**Town of Breckenridge**  
**Planning Commission Agenda**  
Tuesday, September 20, 2011  
Breckenridge Council Chambers  
150 Ski Hill Road

PLANNING COMMISSION MEETING

Planning Commission Staff Report

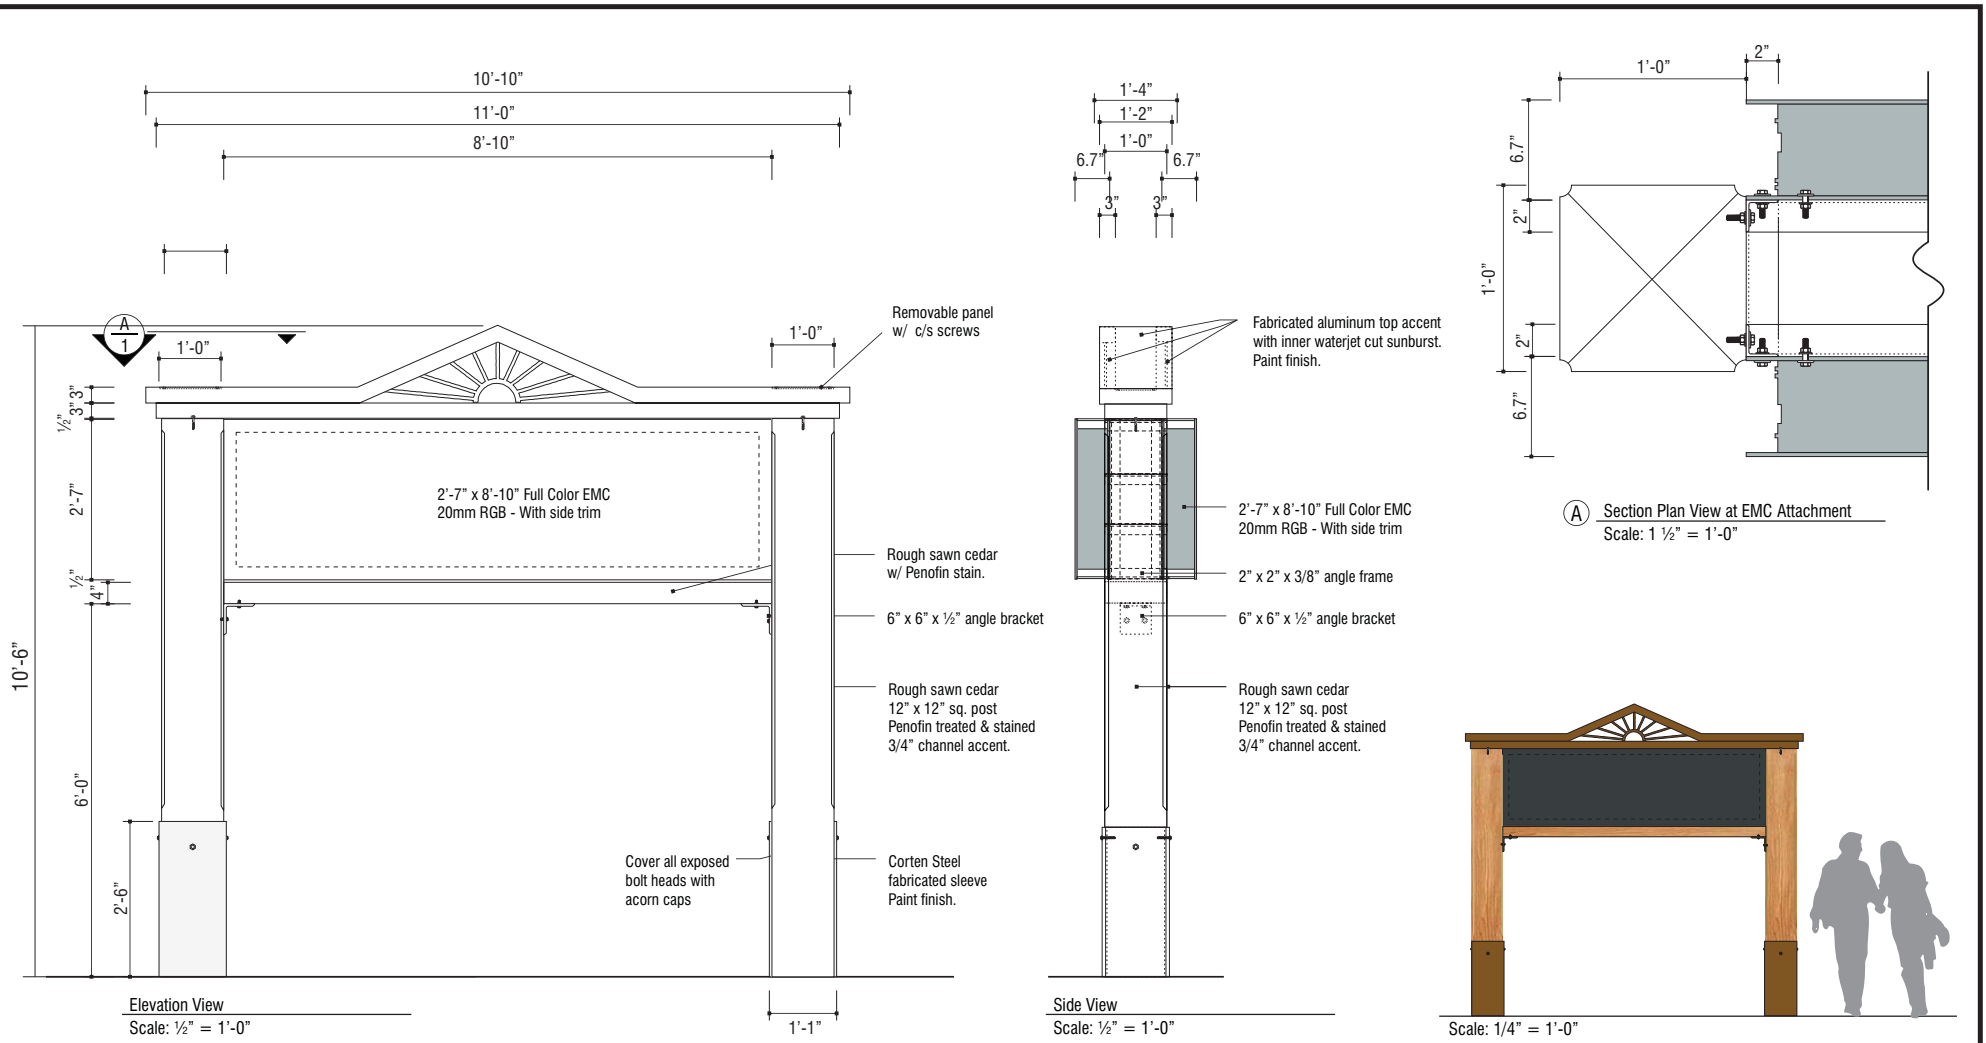
8'10" wide (22.8 square feet). The maximum size recommended by the sign code for commercial signs is 20 square feet. Considering the speed of traffic in this section of the highway, a slightly larger sign is warranted.

**Landscaping:** With most freestanding signs, landscaping of 2 square feet is required for each 1 square foot of sign. In this case, about 46 square feet of landscaping is required. However, this is a traffic/wayfinding sign, and most of the town's traffic and wayfinding signs are not landscaped. Staff believes that landscaping around the proposed sign is still important, not only to soften the visual impact of the sign but also to represent the quality and natural character of the Town. For example, the "Welcome to Breckenridge" sign near the Recreation Center would be much less attractive if not for the landscaping surrounding the stone monument.

We understand that landscaping is not proposed at this time, in case the sign needs to be relocated in the future. While the Town did some "test runs" last year with a rented variable message sign near this location, it's possible that after installation we learn that another location would work better. As a result, the landscaping is not currently planned, but is possible in the future. Staff believes that a firm commitment should be made and budgeted this year for the installation of landscaping around the base of the sign by the end of summer 2012.
